**FINAL**  
**Mitigated Negative Declaration**  
**and Supporting Initial Study**  
for Pacific Gas and Electric Company's

**Embarcadero-Potrero 230 kV**  
**Transmission Project**

**(A.12-12-004)**

## NOTICE OF FINAL INITIAL STUDY/ MITIGATED NEGATIVE DECLARATION

**Figure 4-2**  
**Project Location**

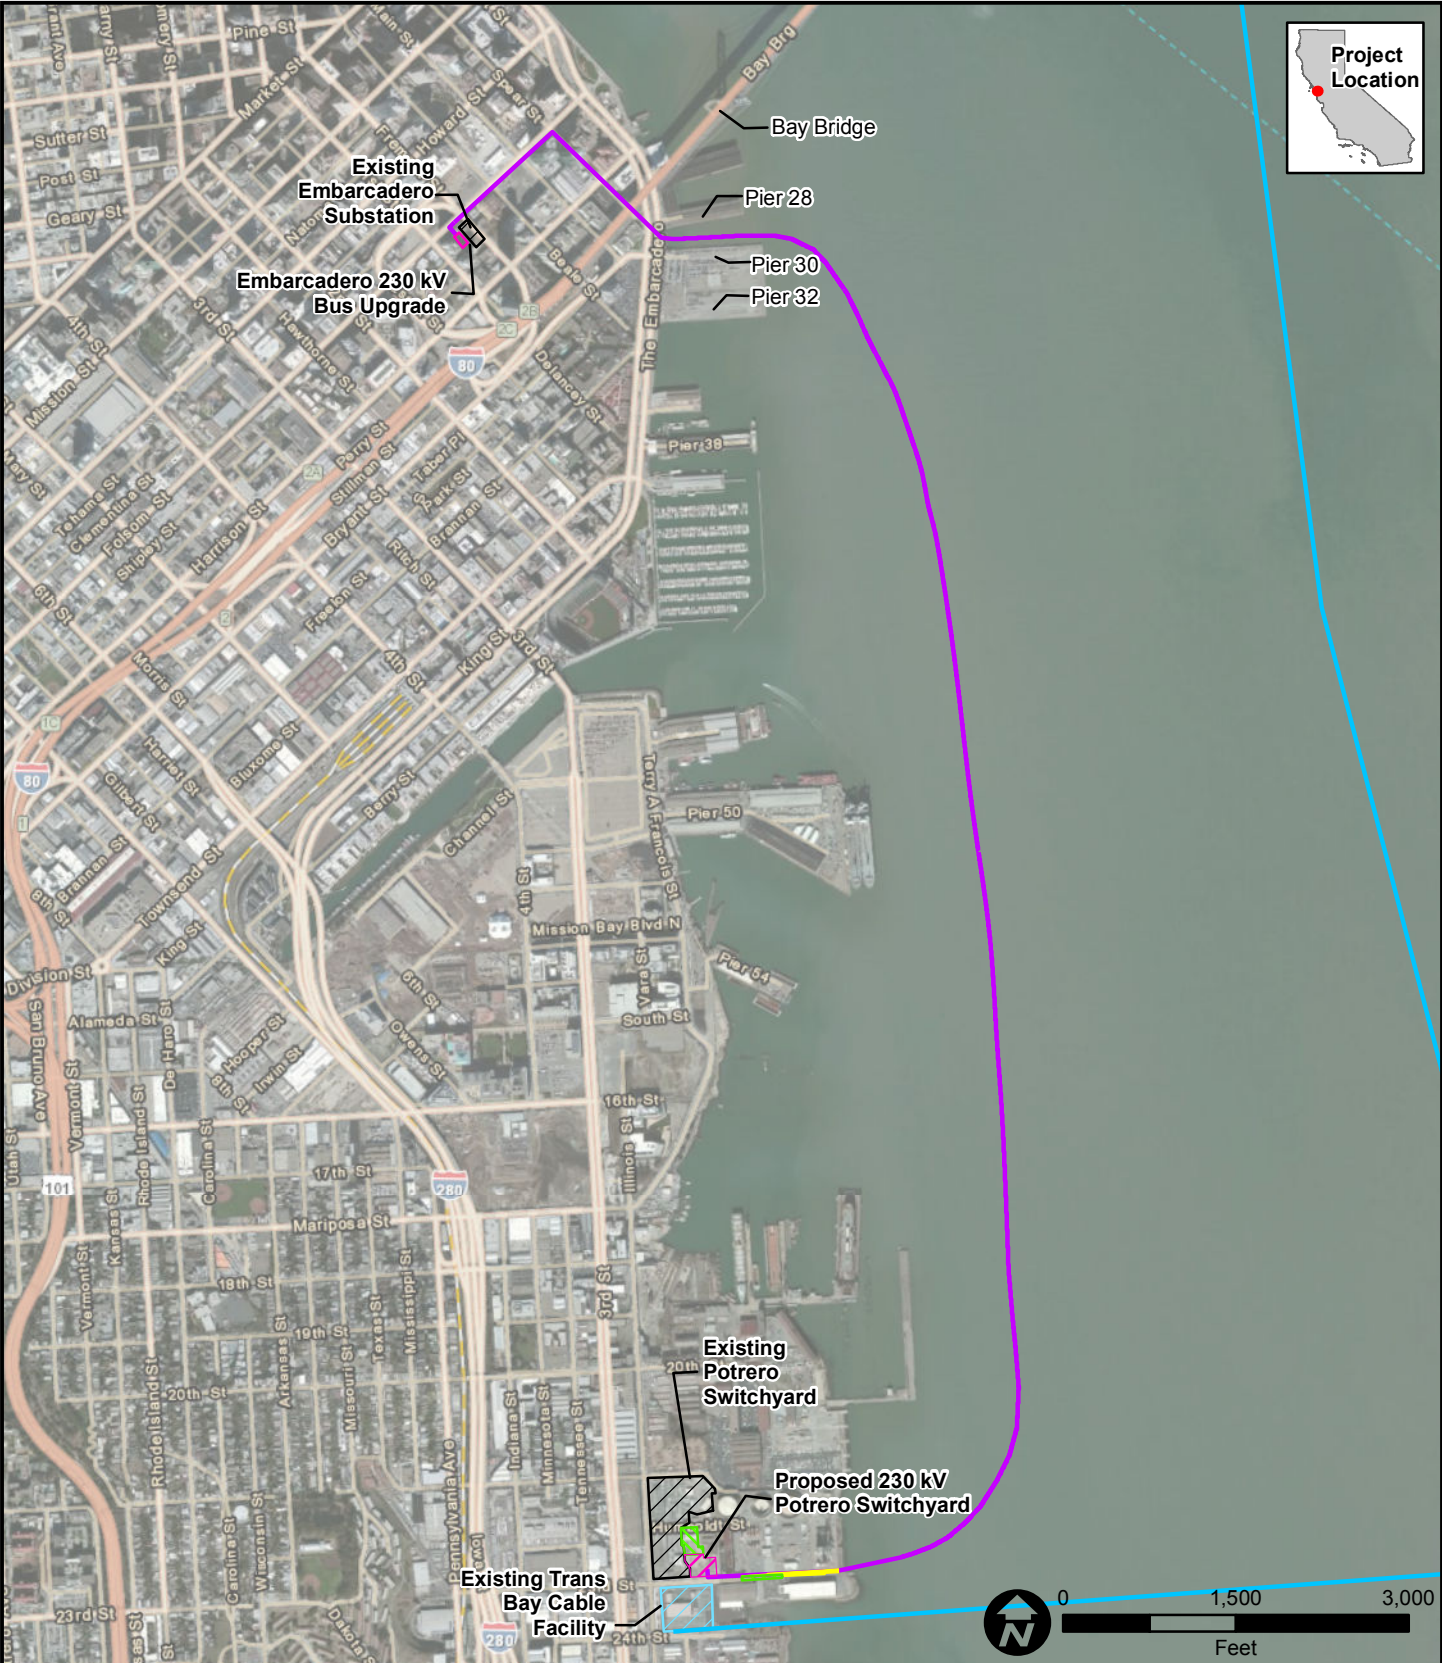
Finally, the Commission may wish to modify figures that generally show the shape of the parcel that PG&E intends to acquire in fee simple and the resulting changes in the shape of the proposed construction staging site (Alternative 1) to ensure consistency with Appendix G to this letter. This may require very minor changes to the polygons in Figures 4-2, 4-4, 4-5, 4-9, and 5-10.2.

**Figure 4-2, Project Location.** The figure incorrectly shows the Trans Bay Cable line on 24<sup>th</sup> Street instead of in 23<sup>rd</sup> Street. The line is on the southern margin of 23<sup>rd</sup> Street, as correctly described on page 4-2 of the MND.

F-6 See Response to Comment F-5 regarding a new Figure 4-14b showing the revised parcel map for private land rights acquisition near Potrero Switchyard. In addition, minor changes to the parcel polygons shown in Figure 4-2 (Project Location), Figure 4-4 (Potrero Switchyard Area), Figure 4-5 (Potential Staging Locations), Figure 4-9 (Potrero HDD Transition Area), and Figure 5.10-2 (Potrero Area Existing Land Use) have been made in this Final IS/MND. See also Response to Comment F-10 regarding additional revisions to Figures 4-2 and 4-4 and the text in Sections 4.11.3 (Staging Areas, Onshore Staging) and 4.11.4 (Easements and Right-of-Way).

**Figure 4-4**

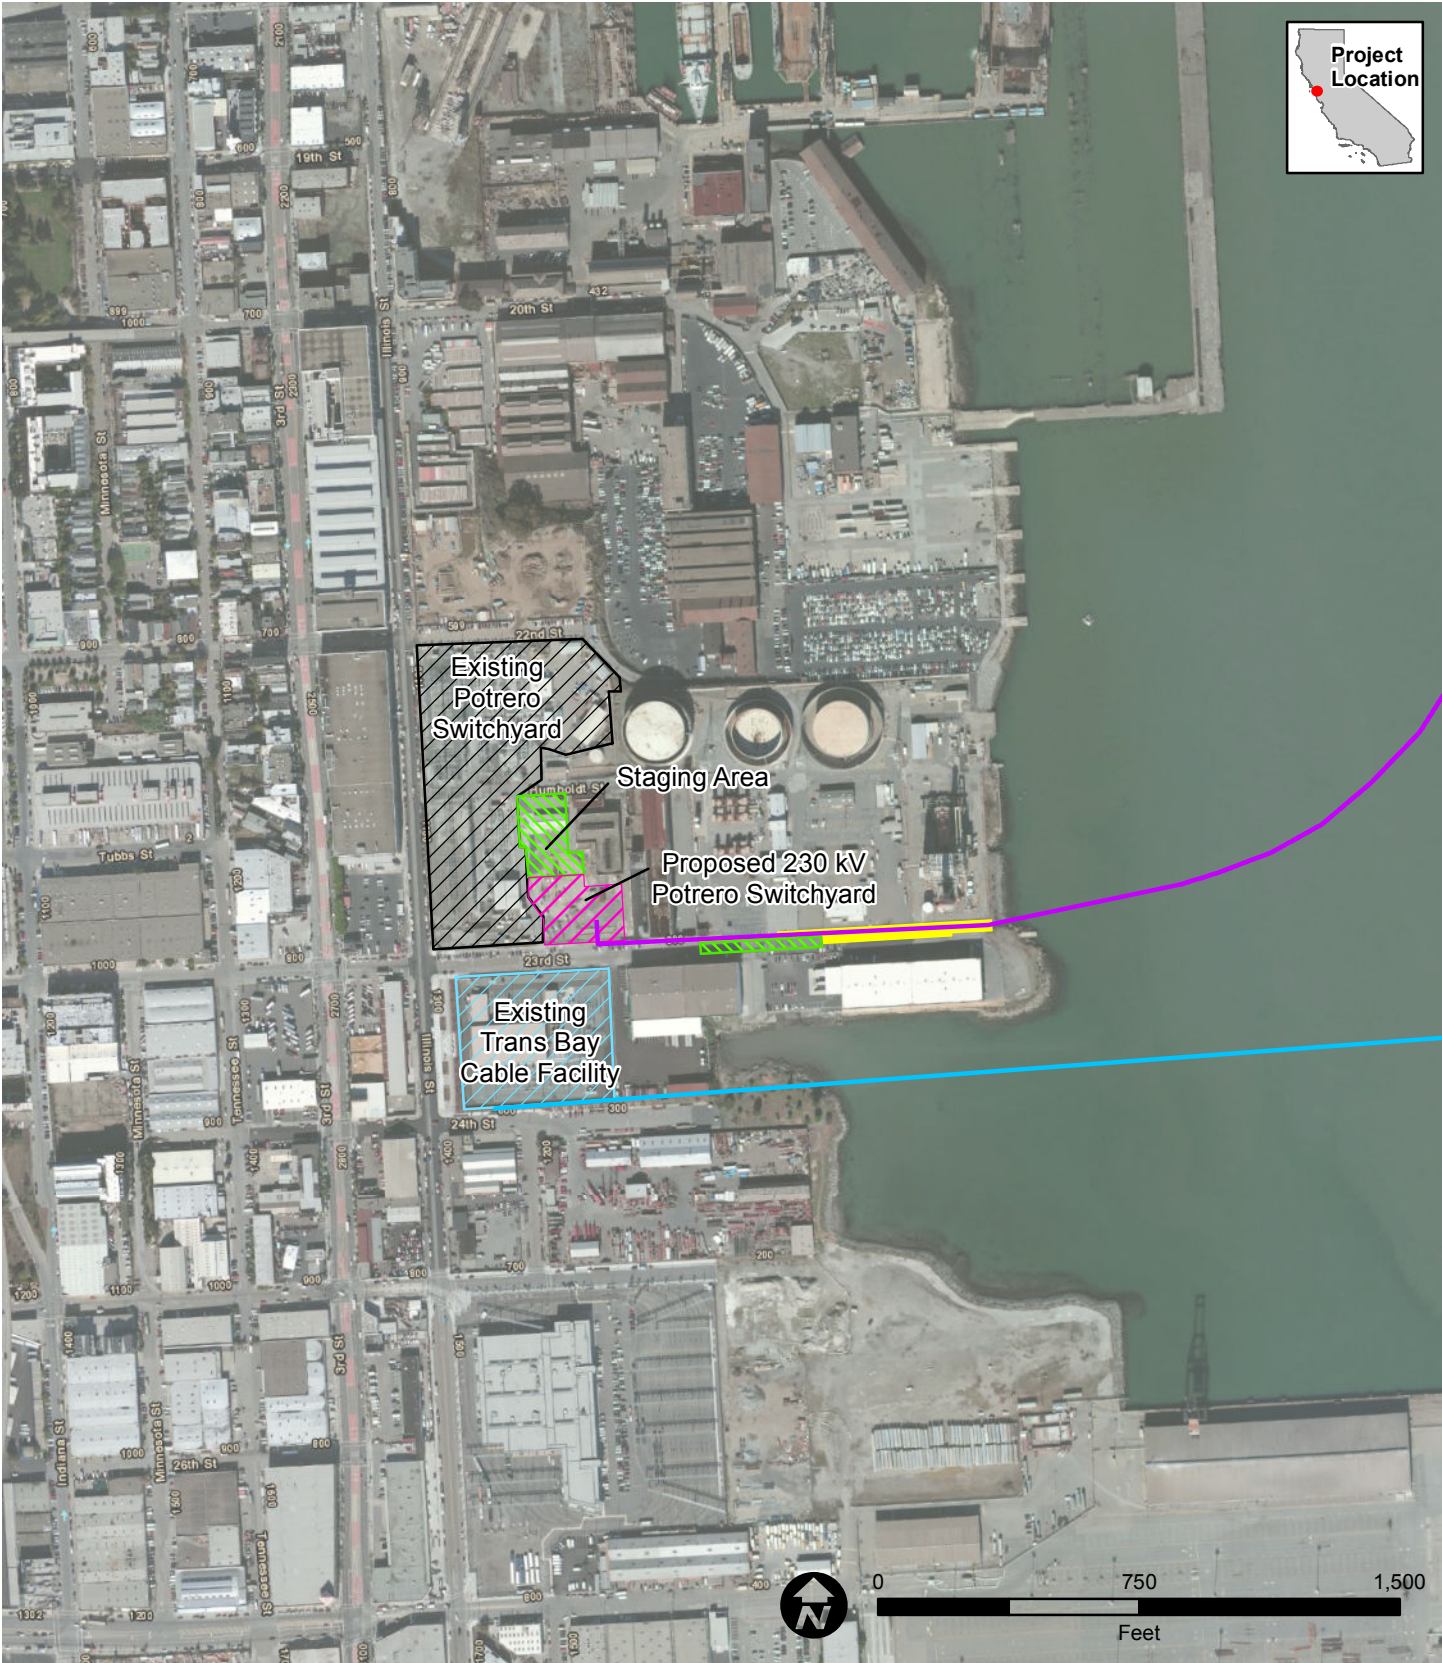
**Figure 4-4, Potrero Switchyard Area.** The figure incorrectly shows the Trans Bay Cable line on 24<sup>th</sup> Street instead of in 23<sup>rd</sup> Street. The line is on the southern margin of 23<sup>rd</sup> Street, as correctly described on page 4-2 of the MND.

**Cross Section of the Proposed 230 kV XLPE Submarine Cable with Double Steel Armoring Design**

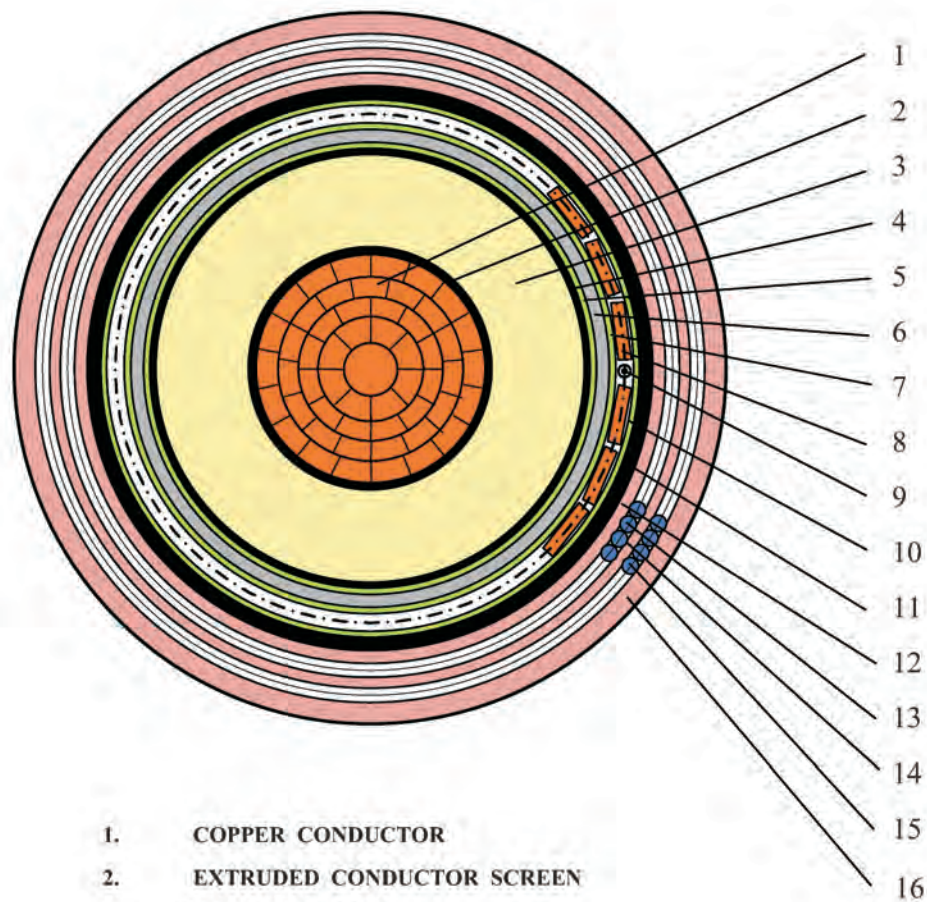
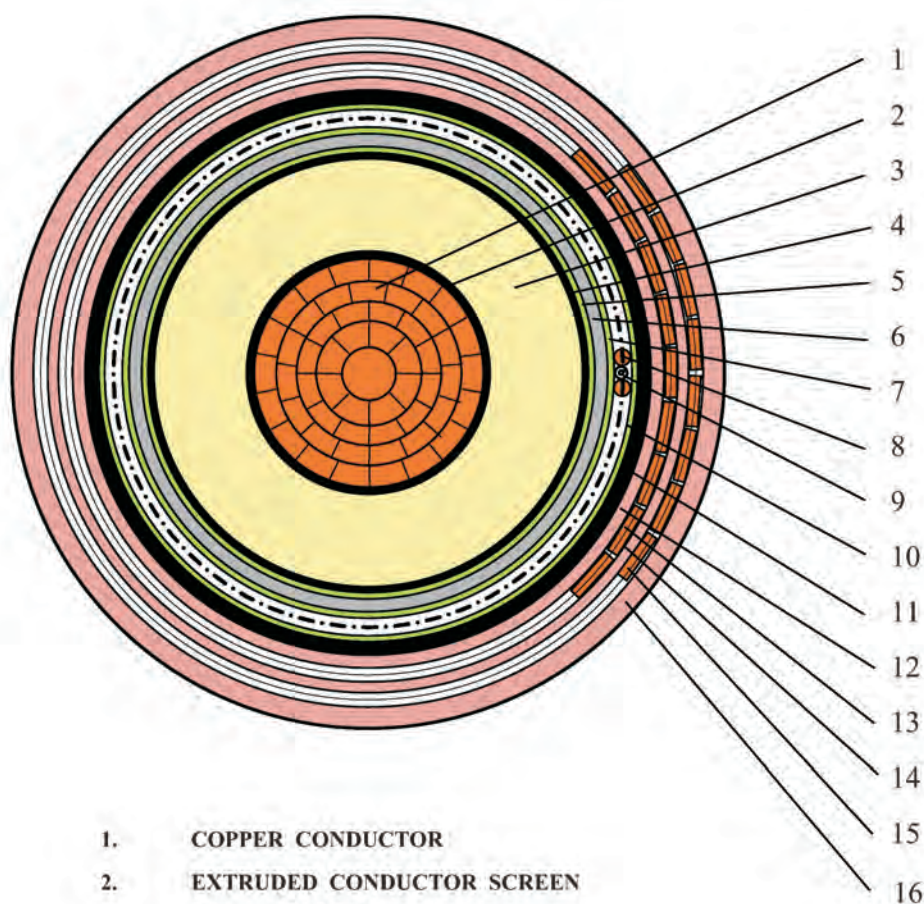
Based on the most recent conceptual design work, PG&E requests that the MND be modified to provide for additional flexibility to accommodate potential design elements that would increase the value of the line without introducing new or different environmental impacts. Specifically, PG&E is now planning to specify two layers of copper or steel armor on the submarine portion of the cable in order to increase its tensile strength. Because Figure 4-13 only shows one layer of copper wire armor, PG&E requests that it be replaced with Appendix H to this letter (double steel armoring) and Appendix I to this letter (double copper armoring), as alternative options.

F-7 Figure 4-13 (Cross Section of the Proposed 230 kV XLPE Submarine Cable) has been replaced in the Final IS/MND with the following two revised figures submitted as Appendices H and I:

**Figure 4-14b**

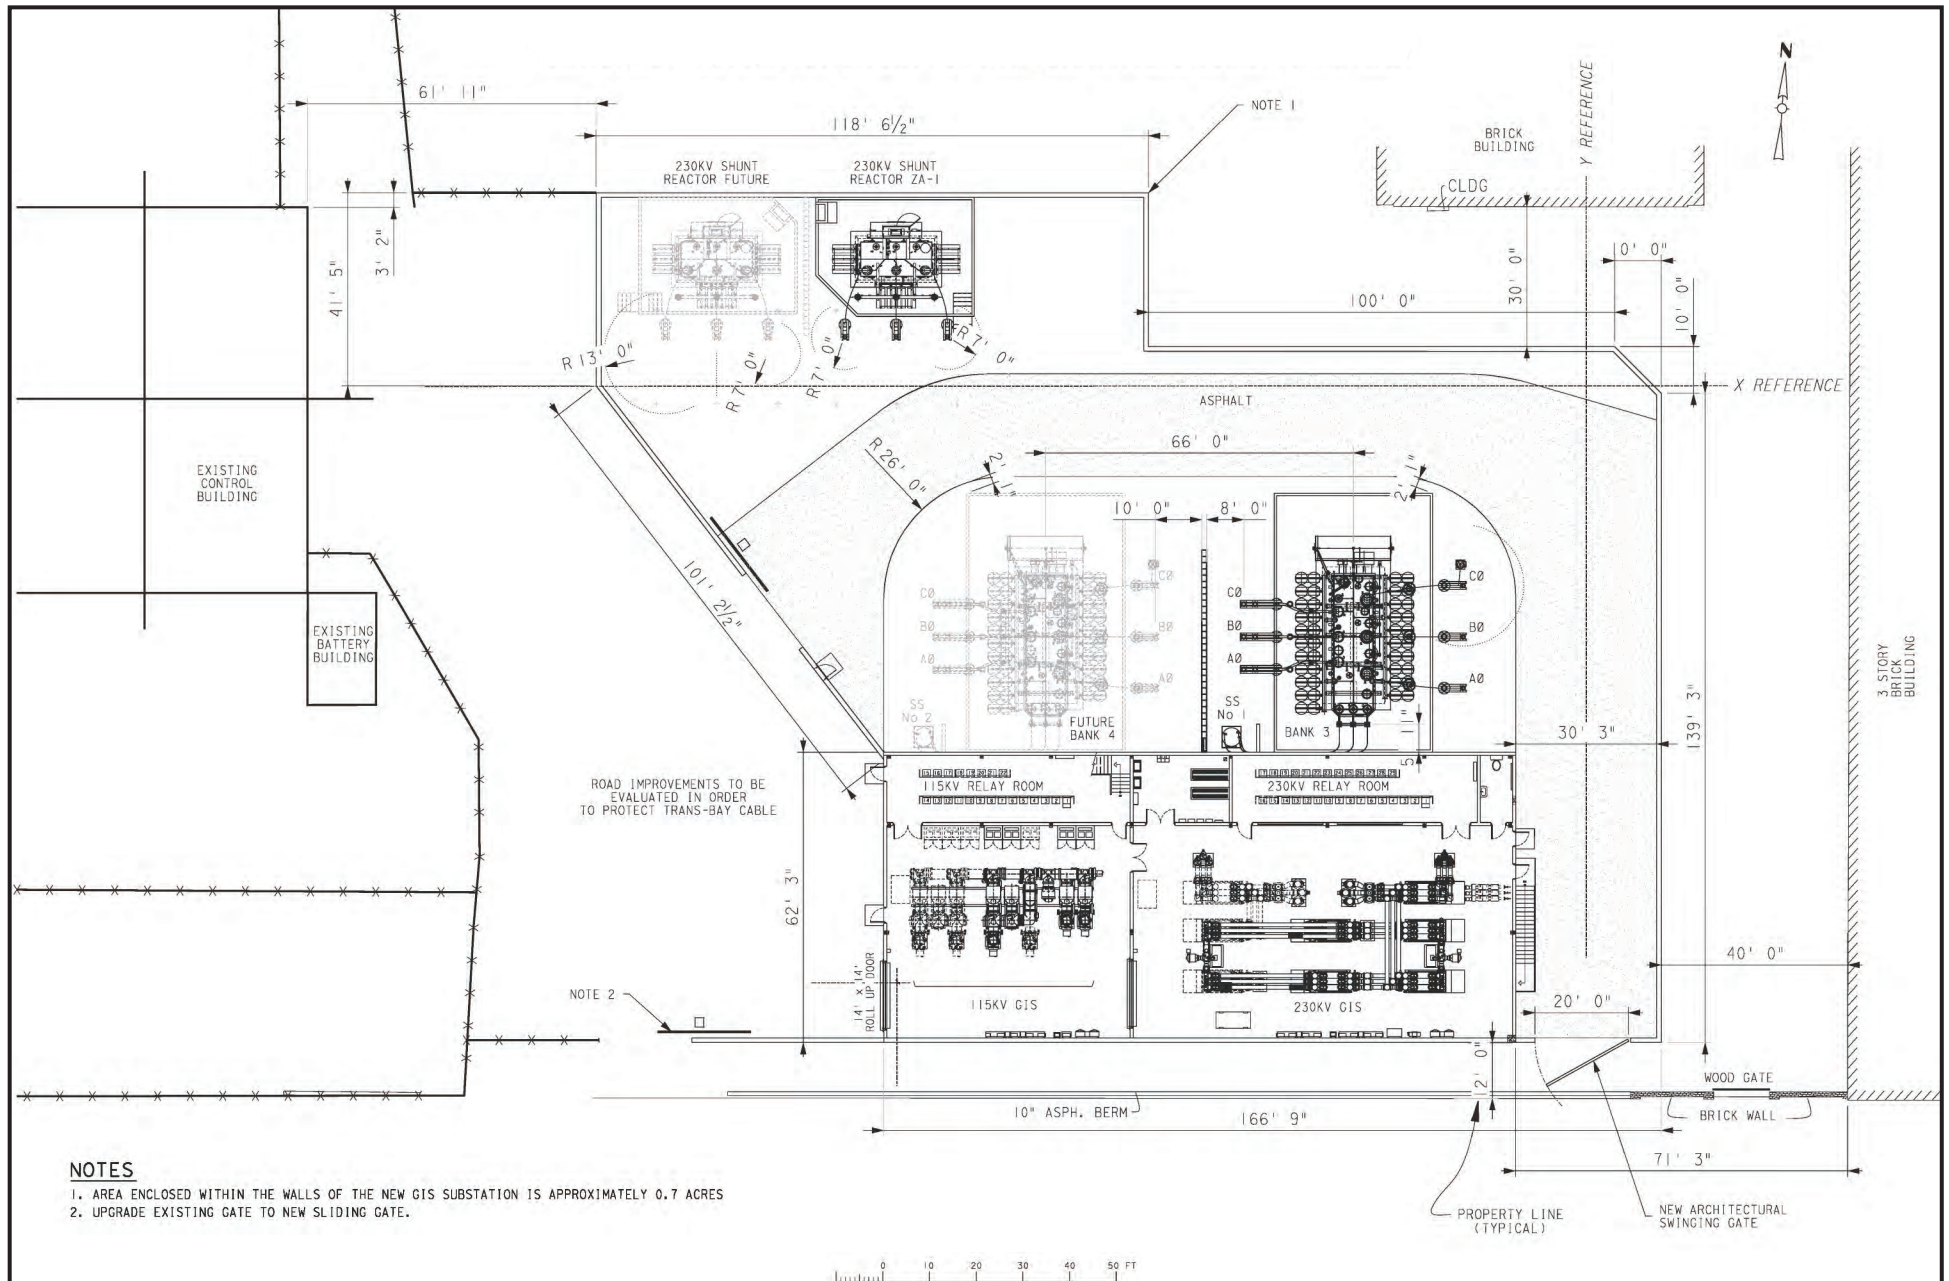
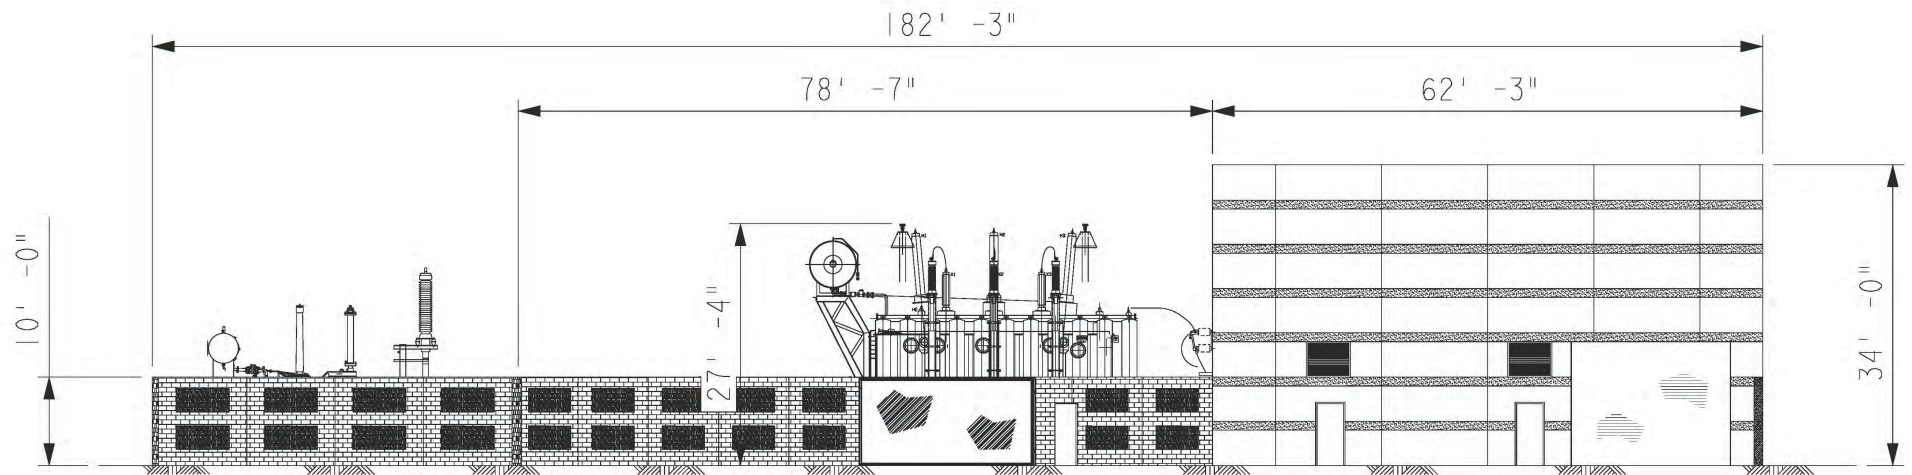
Additionally, the Commission should modify Figures 4-14 and 4-15 in the MND to be consistent with the updated drawings provided in Appendices C-G to this letter. Appendix C is a revised site plan for the switchyard. Appendices D-F are revised elevation drawings showing the current design profile looking toward the east, west, and north, respectively. Appendix G is an aerial view of the area with outlines showing the revised shape of the land rights PG&E intends to acquire from NRG (formerly GenOn), including the land needed for the switchyard and Alternative 1 for the construction staging site.

F-5 Figure 4-14 (Potrero Gas Insulated Switchgear Building Conceptual) and Figure 4-15 (230 kV Electrical Equipment) have been replaced in the Final IS/MND by revised figures submitted as Appendices C-G. The following new figures are included in the Final IS/MND:

- Figure 4-14a (Revised Site Plan for Proposed Potrero 230 kV Switchyard),
- Figure 4-14b (Revised Parcel Map for Private Land Rights Acquisition near Potrero Switchyard),
- Figure 4-15a (Revised Potrero 230 kV Switchyard East Elevation),
- Figure 4-15b (Revised Potrero 230 kV Switchyard West Elevation), and
- Figure 4-15c (Revised Potrero 230 kV Switchyard North Elevation).
